The City of Grove City, Ohio

Staff has reviewed your rezoning application for Pinnacle Quarry located on the west side of Jackson Pike and south side of White Road, in Grove City, Ohio. The control number for this application is #202006300035 and should be referenced on any future correspondence concerning this matter.

PINNACLE QUARRY DEVELOPMENT

PLANNED UNIT DEVELOPMENT-RESIDENTIAL (PUD-R)

PARCEL EXHIBIT

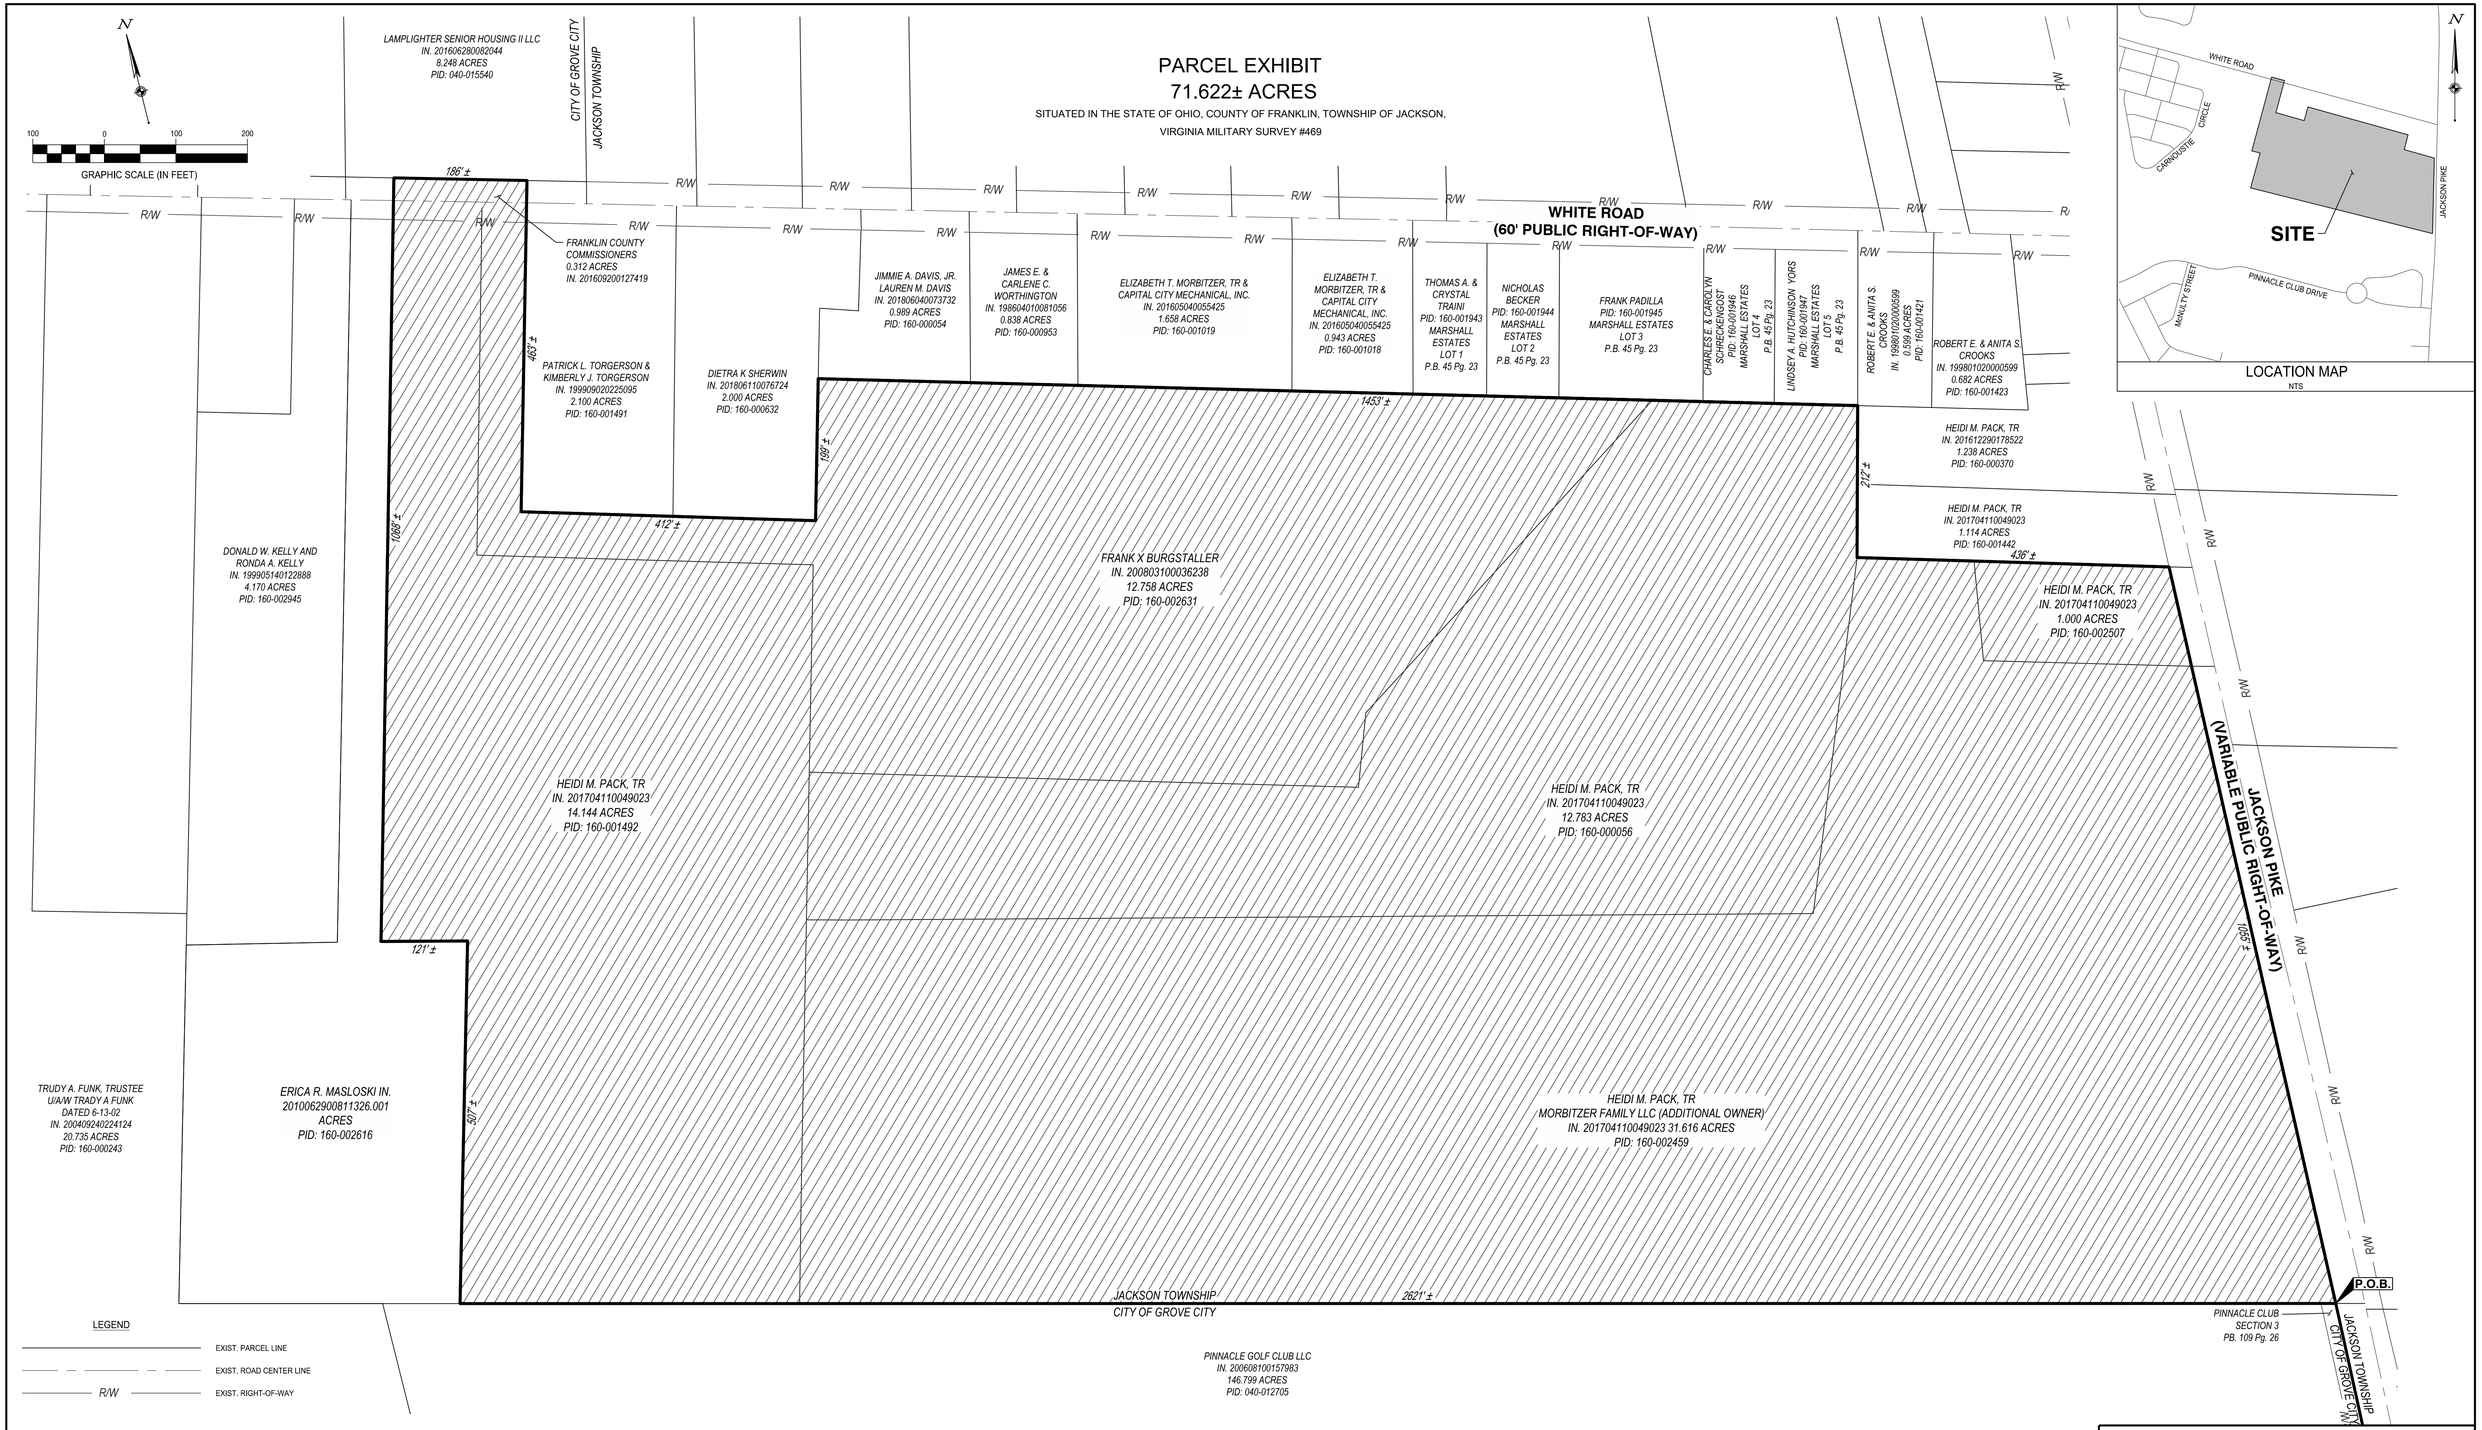
2. Provide an updated survey of the site that does not state it is an annexation exhibit.
